CERTIFICATE OF APPROPRIATENESS**Application Date:** June 28, 2016**Applicant:** Phil Arnett for 2315 Union Street, LLC, owner**Property:** 2315 Union Street, Lot 11, Block 384, Baker W R NSBB Subdivision. The property includes a historic 900 square foot, one-story wood frame single-family residence situated on a 5,000 square foot (50' x 100') interior lot.**Significance:** Contributing residence, located in the Old Sixth Ward Historic District.**Proposal:** Alteration – *Revision. The applicant has removed the original decorative gable trim, gable window, and window trim without a COA. This action was outside the scope of work approved in four earlier COAs for this remodel, and was done without staff knowledge or prior HAHC approval.*

The applicant is now requesting approval for the installation of an appropriate salvaged wood 6-over-6 gable window, the reinstallation of the original wood window trim, and the installation of reproduction wood decorative gable trim that matches the original

Public Comment: No public comment received.**Civic Association:** No comment received.**Recommendation:** Denial - does not satisfy criteria 1, 4, 5, 6, 7, or 9.

PHOTOS OF RENOVATED GABLE WINDOW / TRIM

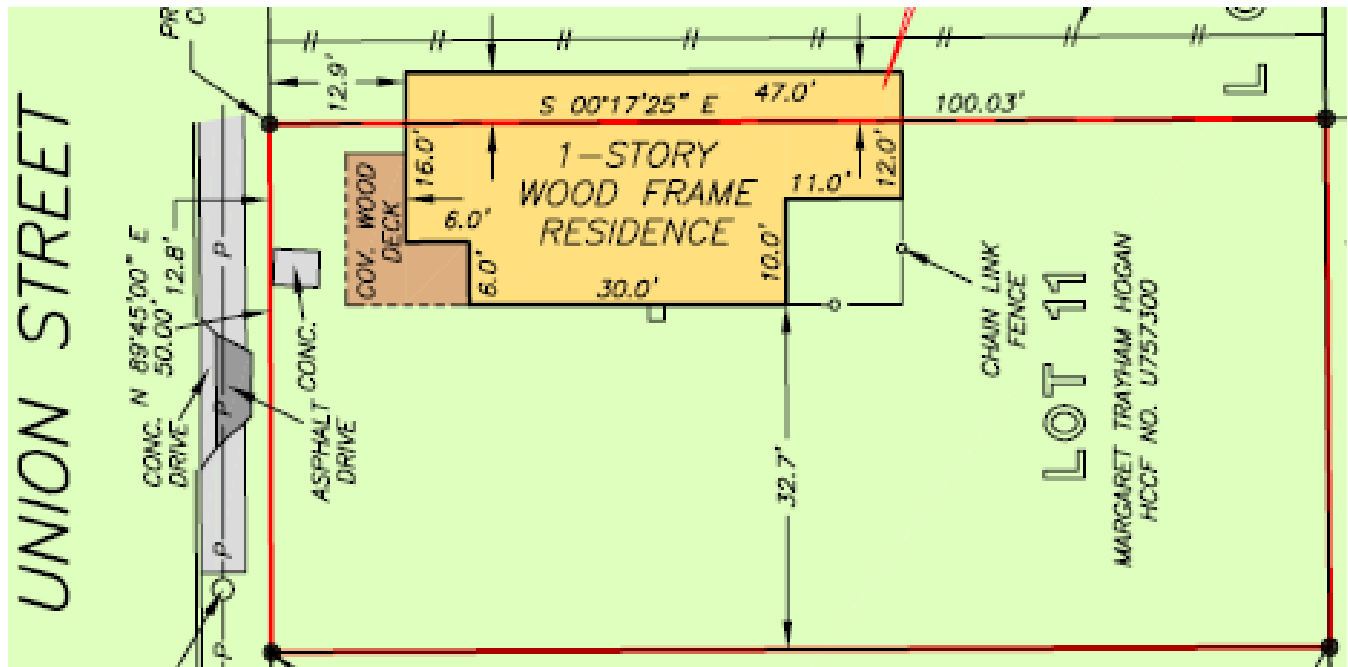
- In March 2016, the applicant installed a 4-over-4 window in the gable; this window did not match the original 6-over-6 window, nor was it approved for replacement

- On May 10, 2016, staff contacted the applicant and instructed him to apply to the HAHC for the outstanding issues with the structure, including: the destroyed decorative gable trim, the replaced gable window, and removal of the trim around all the original window openings

<i>The unauthorized removal of the original wood decorative gable trim with the intention of not replacing it is not visually compatible with the original design of the structure. The unauthorized replacement of the 6-over-6 gable window with a 4-over-4 gable window is not visually compatible with the previously existing window.</i> |

<i>Since the original wood decorative gable trim and the 6-over-6 gable window have been destroyed without HAHC approval, the replacement of these features should be based on an accurate duplication substantiated by physical and pictorial evidence.</i> |
